Shop Drawing Submittal Review

Project Name: Webster University-**ISB**

Copies	No.	Description
1 PDF	221319P01	(Submittal No.'s)
		(Cannon #22 1319-002) - (Paric #15051-) – (WES #607)
		➢ **Sanitary Specialties Product Data:**
		• Wade Floor Drains: FD-1, FD-2, FD-3
		• Wade Floor Sinks: FS-1, FS-2
		• J.R. Smith Floor Sinl: FS-3
		• Wade Floor Cleanout: FCO-1
		• Wade Wall Cleanout: WCO-1, WCO-2

PROJECT NAME: Webster University ISB
LOCATION: St. Louis Missouri
CLIENT PROJ. NO.: N/A
WES PROJ. NO.: 607
SPEC SECTION: 22 1319 Sanitary Waste Piping Specialties
SUBMITTAL ITEM: See Below -

9150 (12X12-10)

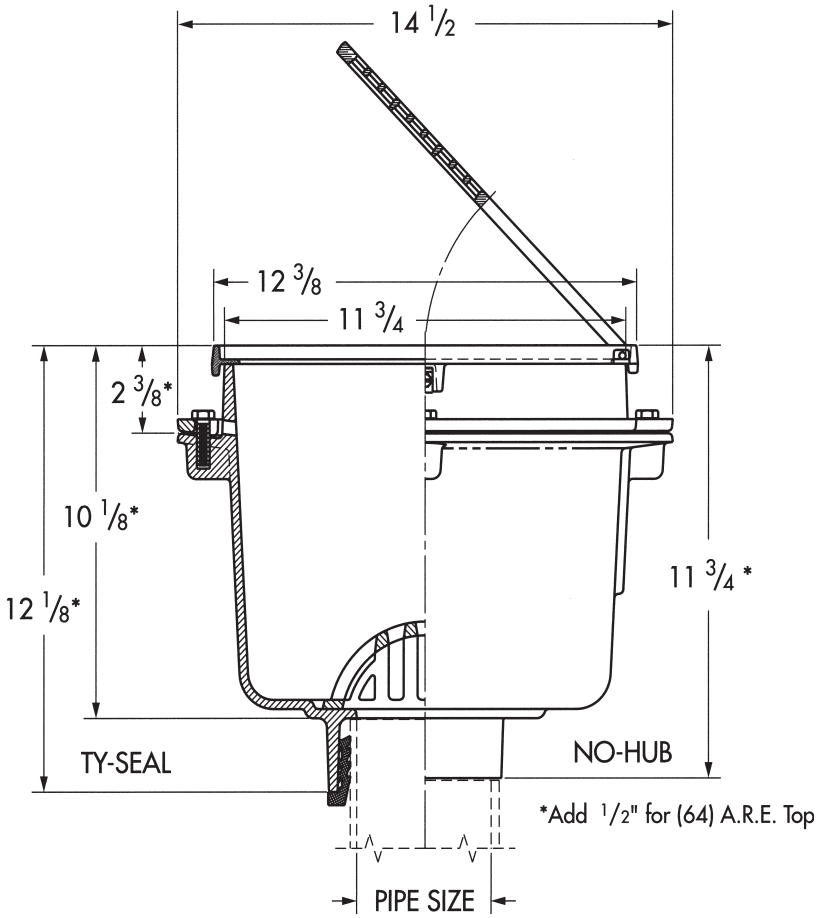
FS-1		**FS-1 FLOOR SINK PER ADDENDUM #2-1**
W915012NH61527	WADE	12” SQUARE, A.R.C. FLOOR SINK, 10” SUMP DEPTH, NICKEL BRONZE - 2" NO HUB, 1/2" TRAP PRIMER CONNECTION, 1/2 GRATE, ALUM SEDIMENT BUCKET
W915013NH61527	WADE	12” SQUARE, A.R.C. FLOOR SINK, 10” SUMP DEPTH, NICKEL BRONZE - 3" NO HUB, 1/2" TRAP PRIMER CONNECTION, 1/2 GRATE, ALUM SEDIMENT BUCKET
W915014NH61527	WADE	12” SQUARE, A.R.C. FLOOR SINK, 10” SUMP DEPTH, NICKEL BRONZE - 4" NO HUB, 1/2" TRAP PRIMER CONNECTION, 1/2 GRATE, ALUM SEDIMENT BUCKET
